**WESTMINSTER PLACE SUBDIVISION,**  
**RESUBDIVISION OF LOT 4 OF THE RESUBDIVISION OF**  
**LOTS 3 & 4**

Engineering Comments:

The following comments should be addressed prior to submitting the FINAL PLAT for acceptance and signature by the City Engineer:

## DETAIL SITE PLAN

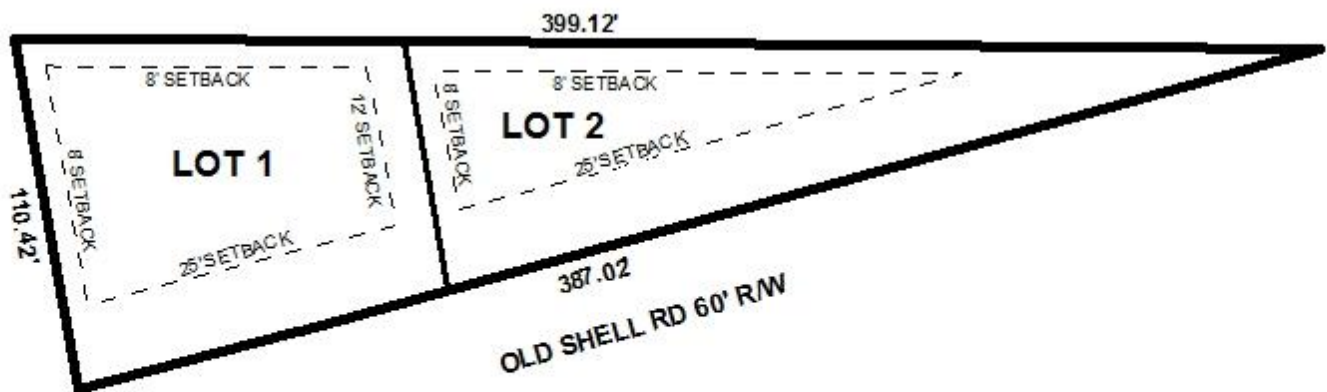
- B. Correct the street name - Border Dr. E., and show existing house and edge of road on Old Shell Rd.
- C. Label the POB and POC listed in the written legal description.

- F. Add a note to the SUBDIVISION PLAT stating the lots will be allowed to add the following amount of impervious area before storm water detention is required: LOT 1 - NONE, LOT 2 – NONE.

The preliminary plat does not indicate the location of the existing curb-cut or development, thus staff cannot determine if the existing house and driveway are fully within the proposed Lot 1. Also, proposed Lot 2 will be triangular in shape and, as proposed, may create a challenging site for new home construction once all applicable setbacks are taken into consideration. Staff has calculated that the buildable area within the depicted setbacks would allow a building to cover 31% of the site, less than the 35% maximum allowed by the Zoning Ordinance. It should also be noted that the side and rear setbacks depicted on the preliminary plat should not be shown on the Final Plat, as there are no side or rear setback requirements in the Subdivision Regulations.

- 1) Retention of the lot size information and the minimum building setback line on the Final Plat;
- 2) Removal of the side and rear setbacks from the Final Plat;
- 3) Placement of a note on the Final Plat stating that Lot 1 is limited to the existing curb-cut to Old Shell Road, with any changes to the size, design and location to be approved by Traffic Engineering and conform to AASHTO standards;

- 4) Placement of a note on the Final Plat stating that Lot 2 is limited to one curb-cut to Old Shell Road, with the size, design and location to be approved by Traffic Engineering and conform to AASHTO standards;
